AS104 NOTES:
CEILING & BAL BEAMS REVISIONS WITH AS104 REVISIONS NOT CLOUDED

SQ ALEXANDRA PARK - BLOCK 11
38 CAMERON ST., TORONTO, ONTARIO M5T 2H2

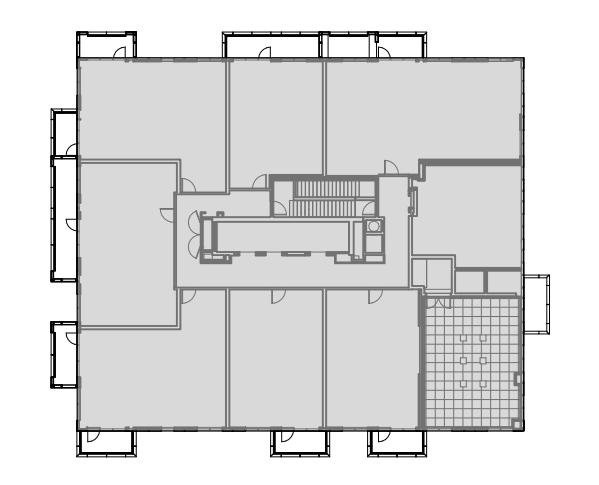
SUITES PH05 AND PH11:
ACOUSTIC CEILING C3 AT ±2750 THROUGHOUT SUITE. ROUTE R/W/ AND/OR CEILING DUCTS AND SPRINKLERS IN TYP. BULKHEADS AT ±2450 BELOW ACOUSTIC CEILING.

ALL OTHER PH SUITES:
INSULATED CEILING C1 AT ±2750 THROUGHOUT SUITE. ROUTE SPRINKLERS AND DUCTS IN TYP. BULKHEADS AT ±2450. INSULATE BULKHEADS - DO NOT EXTEND C1 CEILING ABOVE BULKHEADS.
